ADDENDUM No. 2

RFP No. 18-19/08 - Digital Display Content Management System

ADDENDUM No. 2 (Attachment)

RFP No. 18-19/08 – Digital Display Content Management System

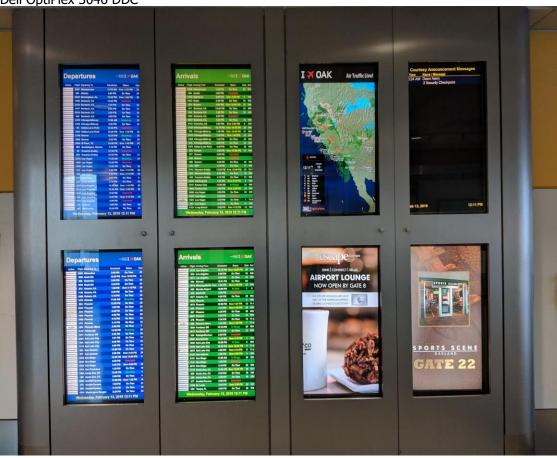
31. Question: Reference II, D.a.e, can OAK provide fairly close-up pictures, at least one of each type, of existing screens so that we can see what information is required and generally how it is laid out?

36. Question: Reference II, D.c., please provide details about the 14 wayfinding sign locations. How many are currently digital? What is the make, model and size of the displays? What is the make and model of the display controllers? Can the airport provide pictures of each location?

Answer: See attached.

Answer: Eight of the displays are located at the ramp leading to the Terminal 1 security checkpoint. Six are entering the concourse post Terminal 1 security checkpoint. (See attached.)

Ticket Counter LG 34 inch Small LCD (2560x1080) /Intel NUC5CPYB NEC 46 inch LCD (1920x1080) / Dell OptiPlex 3046 DDC

Steel Overhead Display NEC 40 inch display (1080x1920) Dell OptiPlex 3046 DDC

CAB NEC 40 inch display (1080x1920) Dell OptiPlex 3046 DDC

Digital Wayfinding 86 inch Intel NUC7i7BNH

GID NEC 40 inch LCD (1920x1080) Dell OptiPlex 3046 DDC
